**Permission sought for a mixed use & residential development on a site area of 6.3Ha, within the Clonburris Strategic Development Zone (SDZ) and in the townland of Cappagh, Dublin 22.**

**CLARIFICATION of ADDITIONAL INFORMATION**

**Reg Ref: SDZ22A/0010**

Fig. 2 – Model of indicative feasibility for entire CUC-S4 lands

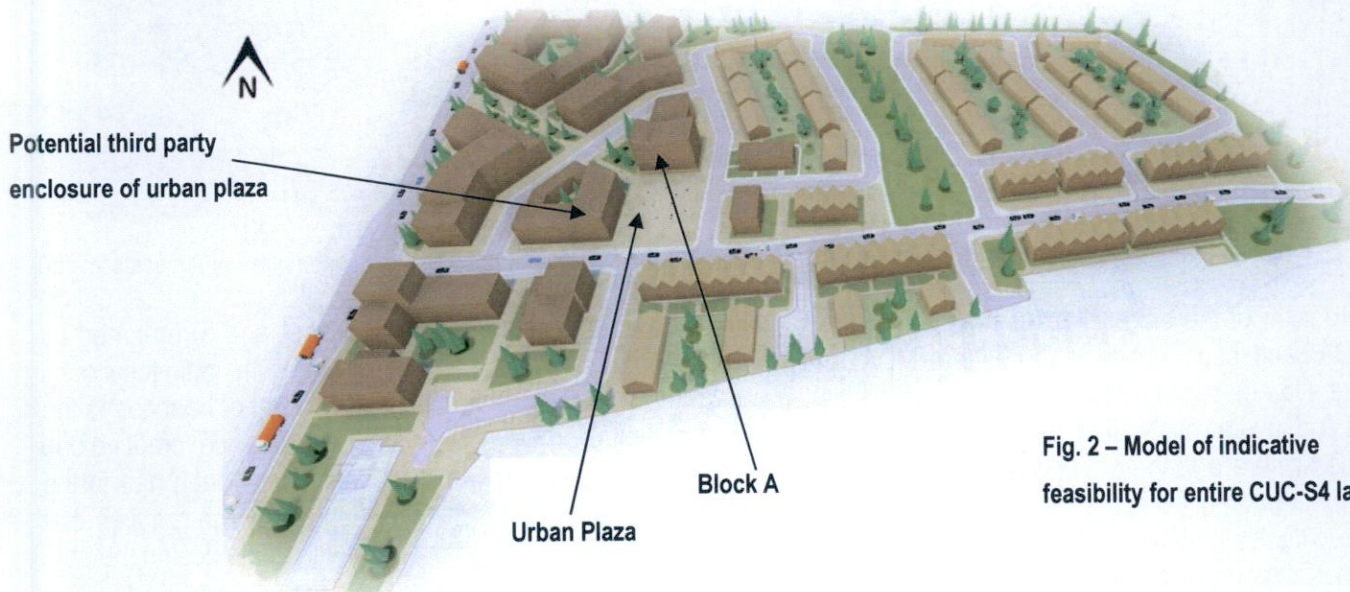
**(a)** *Further information on the opportunities for plaza enclosure on the western and eastern edge of the plaza is required as there are technical concerns with the proposed solutions. Further green infrastructure and SUDS should be incorporated in the public urban plaza.*

In response to this request for CAI, the site layout plan has been revised to create a greater sense of enclosure on the eastern side of the proposed plaza. The site is constrained by the fact that to the immediate south, the permitted Clonburris Southern Link Street abuts the proposed plaza, and to the west, the lands are not in the control of the applicant. Notwithstanding same, as submitted as part of the AI response, an indicative masterplan was prepared indicating how the third-party lands to the immediate west, also located within CUC-S4, may be developed, which allows for the urban plaza to be enclosed on its western side in the future – refer to Fig. 2 below:

Fig. 9 – Sample of proposed boundary treatment along northern & eastern boundaries.

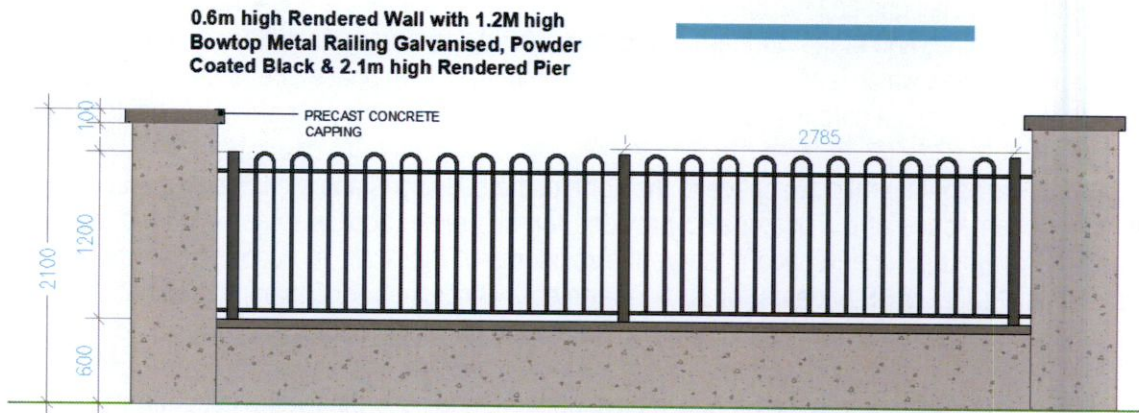
**(a)** *The Planning Authority would have concerns with the retention of the current boundary treatment along the northern and eastern boundaries as part of the proposed development. These spaces are considered vital to the successful delivery of this section of the SDZ. It is therefore considered that the application must engage with the adjoining landowners to provide the Planning Authority certainty as to the delivery of these areas. As a minimum the replacement with a more visually acceptable boundary treatment should be facilitated through this application.*

It is proposed to provide a low (600mm) butt wall with and 1.2m bow top railing atop along the northern boundary of the proposed development, with punctuations along same affording access onto the existing paths that lead to the train station. A sample of the proposed boundary treatment is illustrated in Fig. 9 above, with further details provided on the submitted RMDA drawing no. 02 BP. The applicant has engaged with the adjoining land owner, CIE, informing them of this proposal and it is our understanding that there is no objection in principle from CIE

Along the eastern boundary of the site, there is an existing 1.2m railing which is to be retained and made good where necessary. In addition, a native hedgerow will be planted along same thus softening the aesthetics of same.

Adjacent to both the northern and eastern hard boundaries, a native hedge (e.g. hawthorn, holly, hazel) will be planted (i.e. along the northern boundary and from the north-east corner of the application site running southwards to the Clonburris Southern Link Street, at the junction with the Ninth Lock Road). In addition, along the northern boundary, whip and tree planting is proposed such as alder, hazel and silver birch. Please refer to the submitted Landscape Plan (drawing no. 01 by RMDA) for details, as well as their sections drawings i.e. drawing no. 03(III) SCT "Landscape Sections (iii)" for details.

Fig. 13 – Revised / updated part of Site Layout Plan (along southern boundary) now put forward for permission, as part of this Clarification of Additional Information response

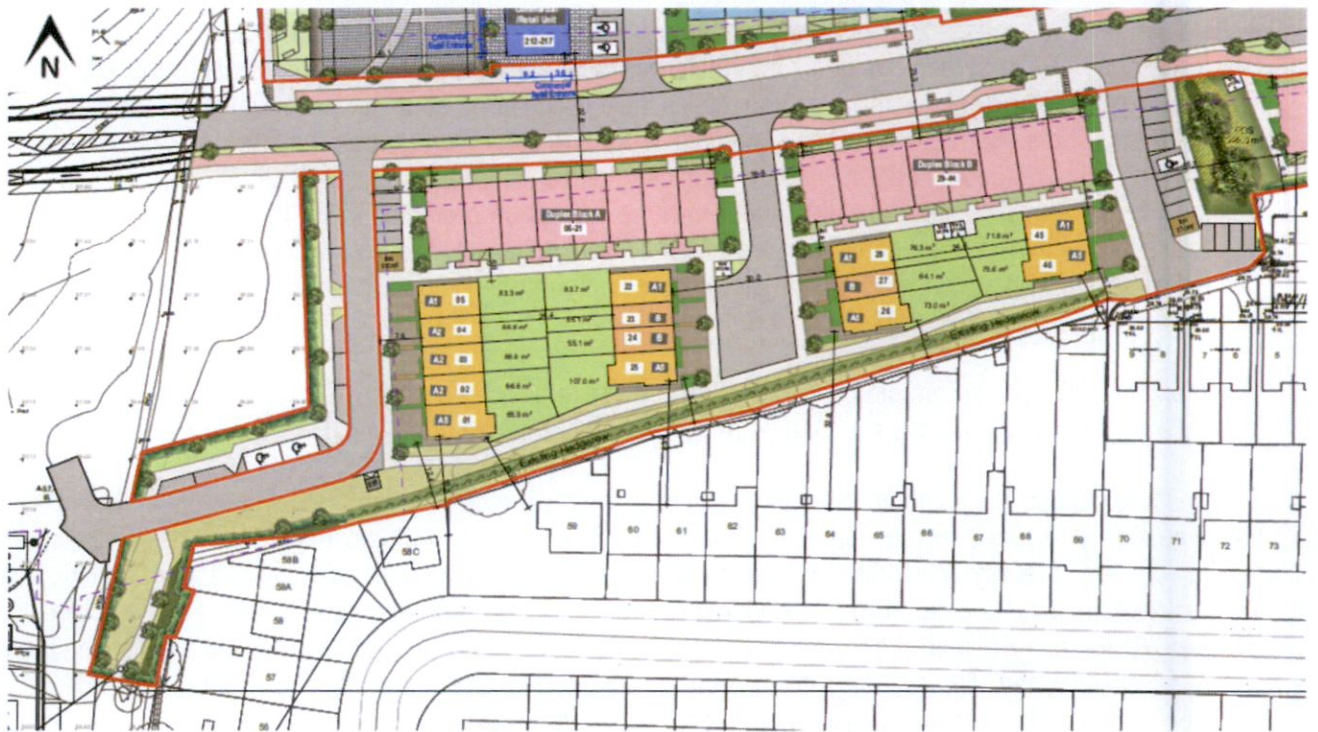
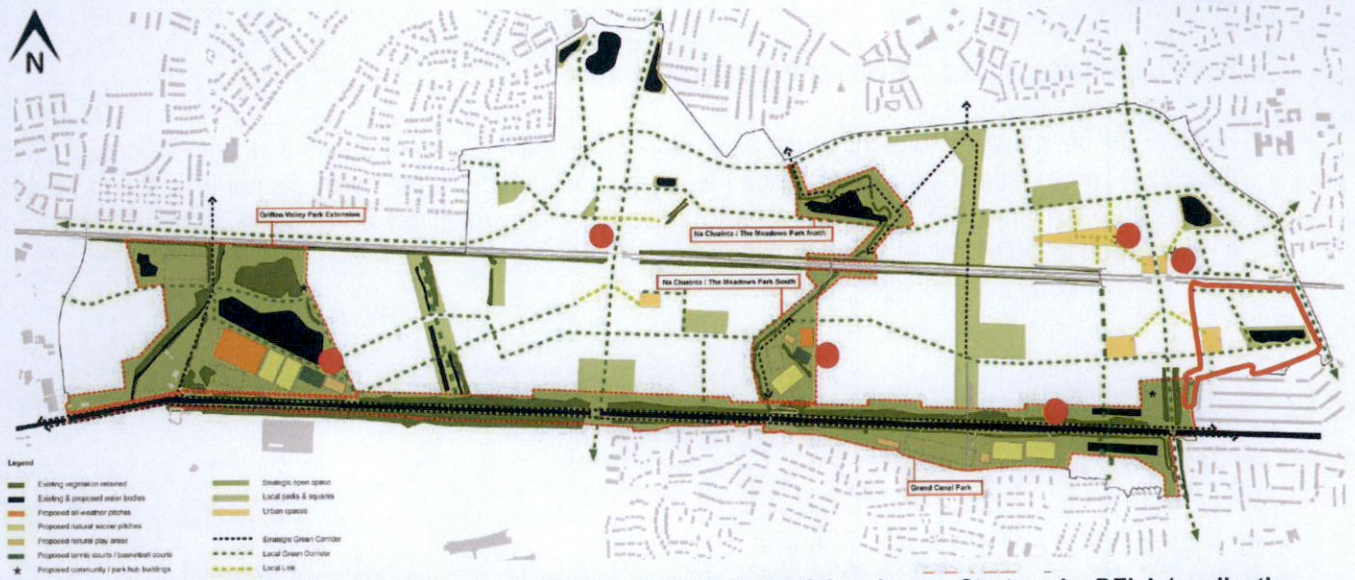
**(b)** *The Planning Authority and Public Realm Section would have concerns with the loss of habitat onsite and green infrastructure proposed. It is not considered that the proposed development fully complies with the agreed Parks and Landscape Strategy for the SDZ.*

The hedgerow along the southern boundary will be retained with the proposed housing to the immediate north of same amended to facilitate the retention of the hedgerow. A dust footpath (e.g. Ballylusk or similar) can be facilitated along here, which will allow access to green links, both from the proposed development and the adjoining Whitton Avenue. End houses will directly address same, being dual frontage thus allowing passive surveillance of this area. The site layout plan in the south-west corner of the site has been revised by way of omitting the previously proposed Block B and thus reducing the amount of car parking along the street. Fig.s 12 and 13 illustrate the previous version of the site layout plan and the current revised proposal respectively. The current proposal further retains and enhances the green infrastructure by catering for green infrastructure links and retention of the hedgerow along the southern boundary.

Fig. 21 – Copy of section P – illustrating the proposed landscaping detail E-W across the westernmost local street south of Clonburris Link Street

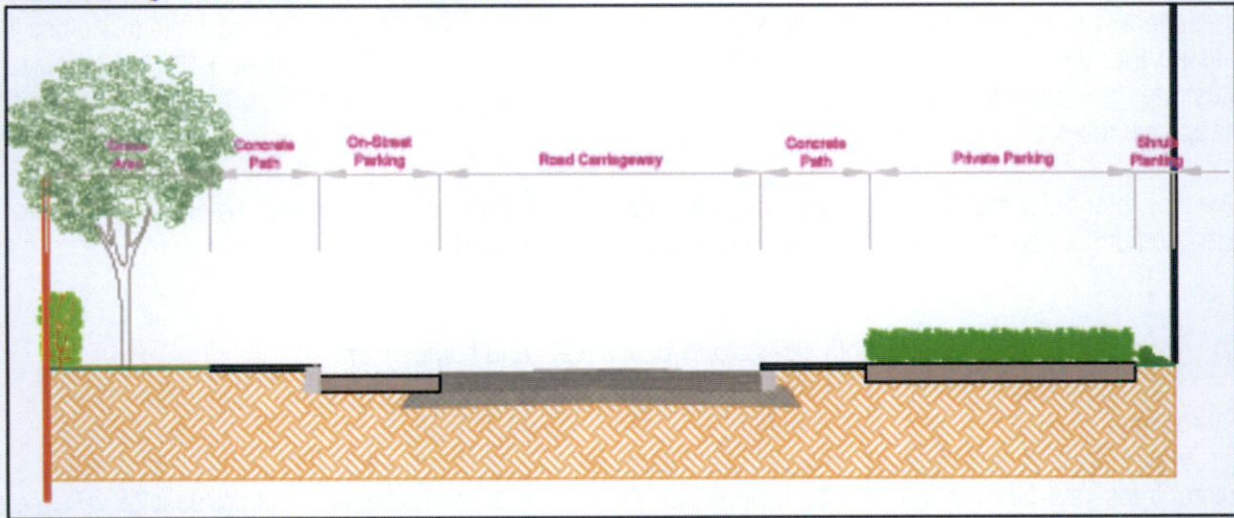
- (d) A Local Green Corridor approximately N-S and E-W along the westernmost local street south of Clonburris Link Street incorporating nature based SuDS: planting proposals require strengthening as there is no difference between it and the tree planting proposed on the other local streets and homezones.

The area in the south-west part of the site has been amended whereby the previously proposed Block B has been omitted from the scheme, along with the omission of car parking along this street. The Green Corridor located N-S and E-W has been supplemented by the use of wildflower planting and native hedge planting. The tree planting has been revised to include native tree species, to differentiate it from local streets and homezones, and details of same are provided for on the submitted RMDA Landscape Plan (drawing no. 01 by RMDA), as well as their sections drawings i.e. drawing no. 03(III) SCT "Landscape Sections (iii)" for details – namely sections P & Q – with copies

of same illustrated in Figs 21 & 22 below. Please also refer to page 14 of the submitted RMDA A3 booklet for more details.

Fig. 23 – Copy of plan of retained trees, new trees and removed trees as part of proposed development.

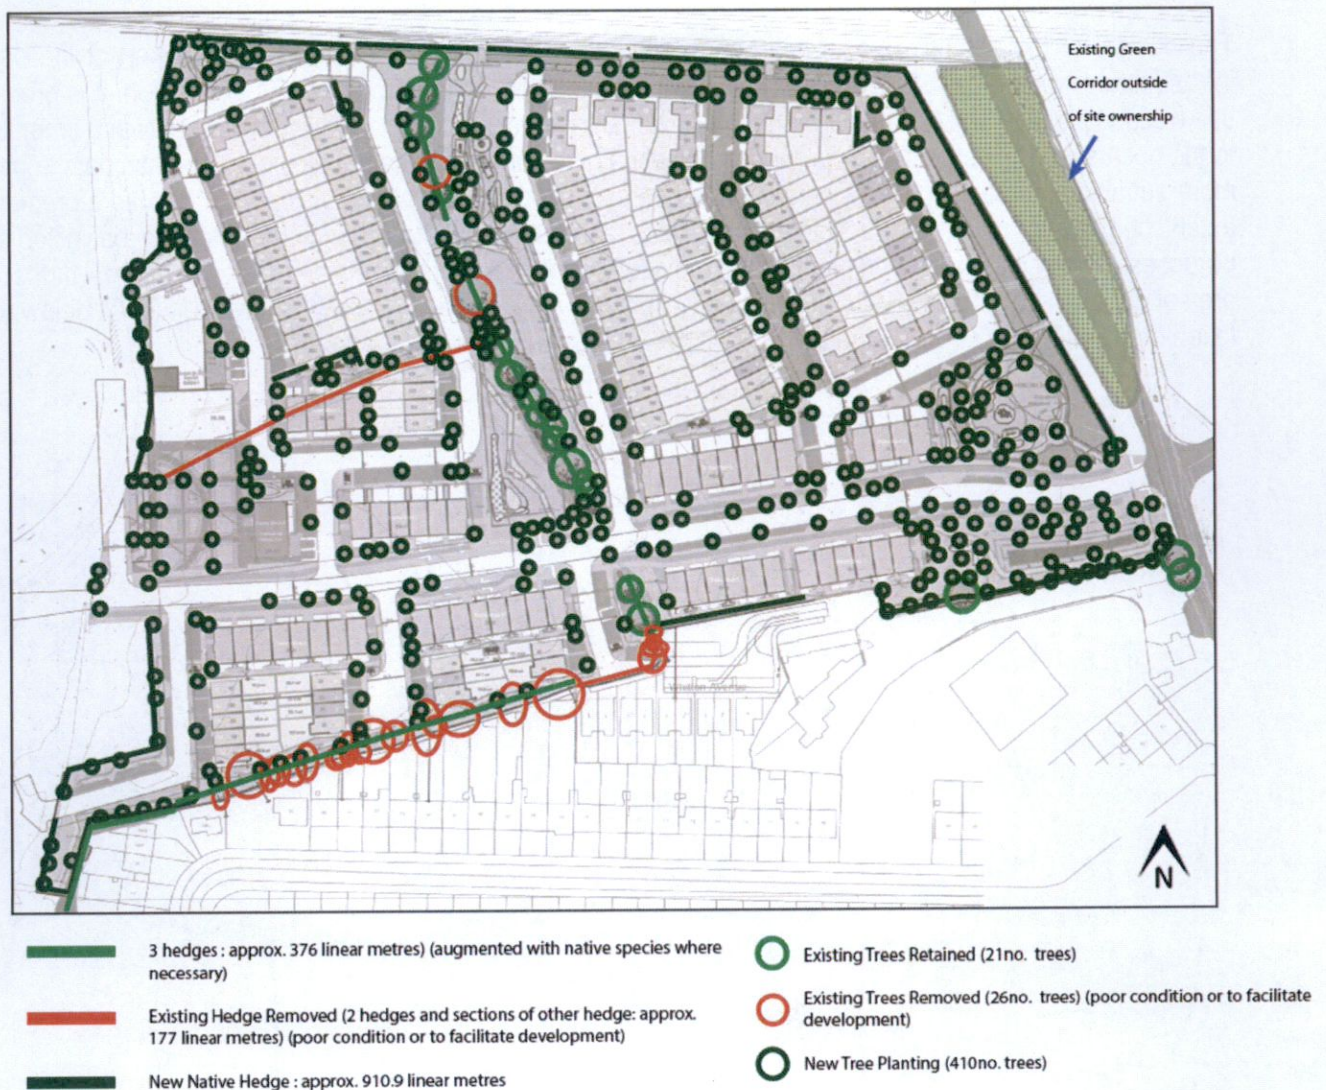
*ii) shows the amount of trees and hedgerow being removed and the amount of compensatory/replacement trees and hedgerow being planted as part of the proposals. To be in compliance with the SDZ and the requirement of no net loss of hedgerow across the scheme, the amount of compensatory/replacement hedgerow provided in this development shall be at least equal to that being removed. Trees and vegetation within what will be privately owned or inaccessible spaces (rear gardens) cannot be relied upon as compensatory planting that will be appropriately retained and managed. The applicant should also be cognisant of retaining or planting hedgerows/vegetation so that it is incorporated into open space and areas that will be appropriately managed and accessible.*

The submitted RMDA A3 booklet (page 17) illustrates the quantum of trees and hedgerow being removed and those that are being planted (copy of same shown in Fig. 23 below). It is intended that prior to the commencement of development, a protective fence will be erected around the central N-S and southern E-W hedge to protect the hedge structure.

The hedgerows/vegetation located centrally will be accessed via the large centrally located public open space, while on the southern hedge, a 4-5m buffer strip will be implemented to further protect it, with the site layout plan having been amended to cater for same. This hedge will be left open so it can be maintained and augmented, if necessary.

It is evident from the submitted arborist and landscape architect's drawings and details that the number of new trees to be planted (410 no.) greatly exceeds the number of trees to be removed (26 no.), in addition to the 21 no. trees being retained on site, with additional whip planting also proposed. Furthermore, new native hedgerow is also proposed (approx. 910.9 linear metres). Currently, there is 553 linear metres of hedgerow on site, of which 177 linear metres is proposed to be removed to facilitate development. The result is that 1,286.9 linear metres of native hedgerow will be provided on site, approximately 2.3 times the existing hedgerow.

Fig. 25 – Proposed tree pits and street trees location plan

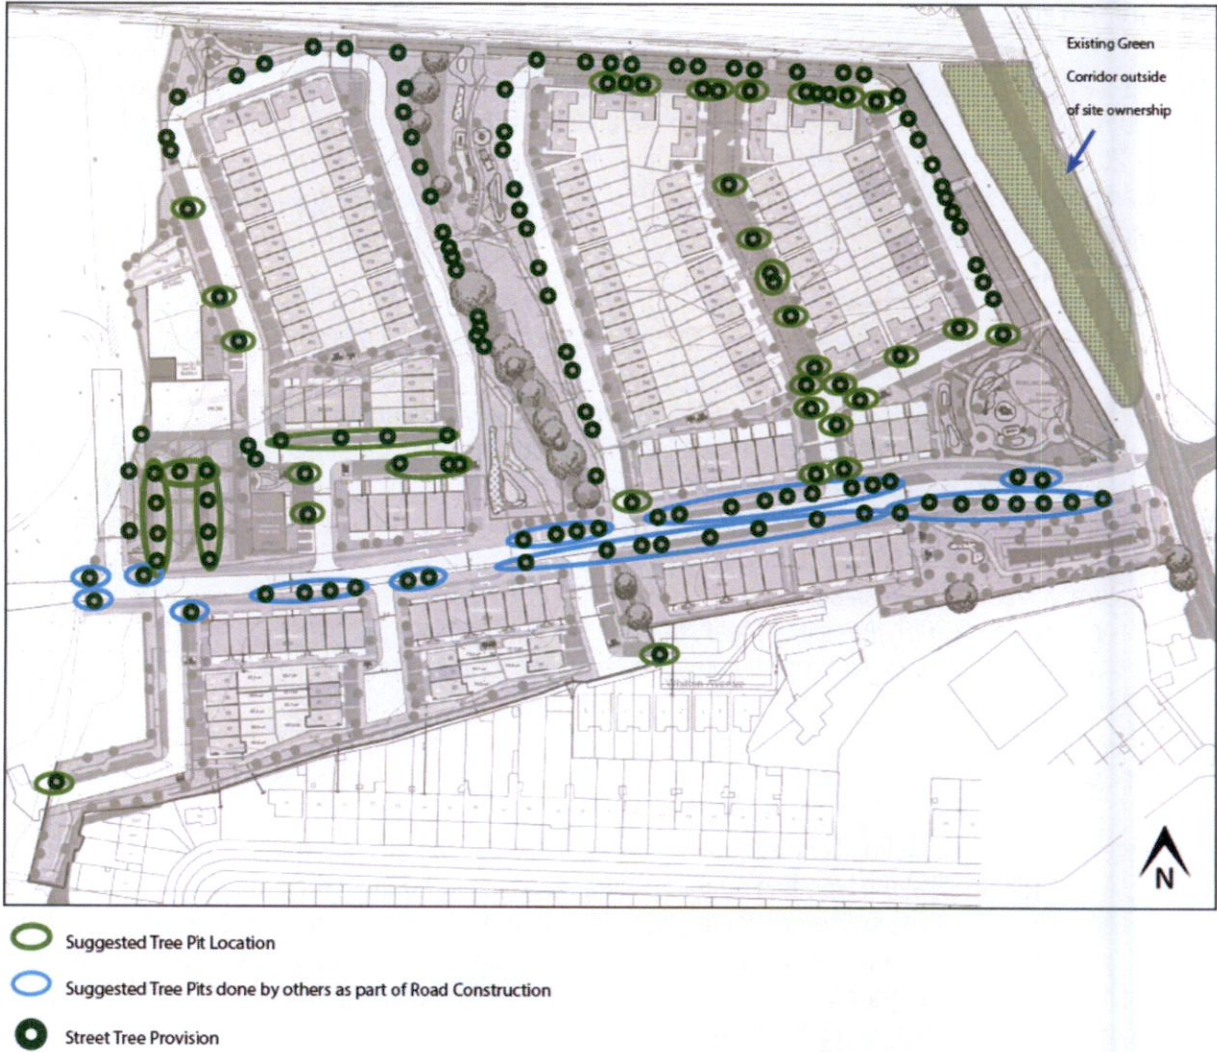
*There is very poor street tree provision throughout the development. The planning scheme requires: 'Streets should be generously planted at frequent intervals to soften the impact of parking and strong building frontages at intervals of 14 – 20 metres. In the interest of biodiversity and place making, reduced spacing between street trees should be considered where appropriate and achievable. (Planning Scheme P64)'. A high quality of Street Tree planting is required throughout the development to strengthen Green Infrastructure links. Landscape proposals are required that demonstrate:*

- i. All Streets: Street Trees to be provided as per the Clonburris SDZ Planning Scheme.*
- ii. Street Trees to be provided fully in Public Areas to be an integral part of the street rather than in front gardens. The applicant is referred to the Clonburris SDZ Planning Scheme 2019, Clonburris SDZ Parks and Landscape Strategy and DMURS (2019) for guidance on street tree provision and appropriate design layouts for local streets and homezones.*
- iii. All Street Trees planted within the Public Realm shall have suitable tree pits that incorporates SuDS features including sufficient growing medium.*
- iv. Street Trees to be planted at:*
  - Minimum 18-20m girth along local streets*
  - Minimum 16-18cm girth on intimate local roads, i.e. homezones*

There are a number of constraints on site which preclude the planting of street trees, however, the submitted details by RMDA confirm the location, type and quantum of tree planting throughout the proposed development. All streets have been provided with street trees where possible, and in local streets and homezone areas. All street trees planted within the public realm have been provided with suitable tree pits, incorporating SuDS features, with details of tree pits also enclosed (refer to page 21 of enclosed RMDA A3 booklet). There shall be a minimum of 16cm<sup>3</sup> of growing medium for each tree. Refer also to Fig. 25 overleaf.

Street trees will be planted at:

- Minimum 18-20m girth along local streets
- Minimum 16-18cm girth on intimate local roads, i.e. homezones

RMDA, however, note that these have a higher note of failure due to size, and as such they have provided an alternative list with smaller sizes due to availability of trees and to prevent larger trees from not adapting to ground conditions when planted. It is their view that a size smaller would be more beneficial & sustainable 14-16cm. - 16-18cm.
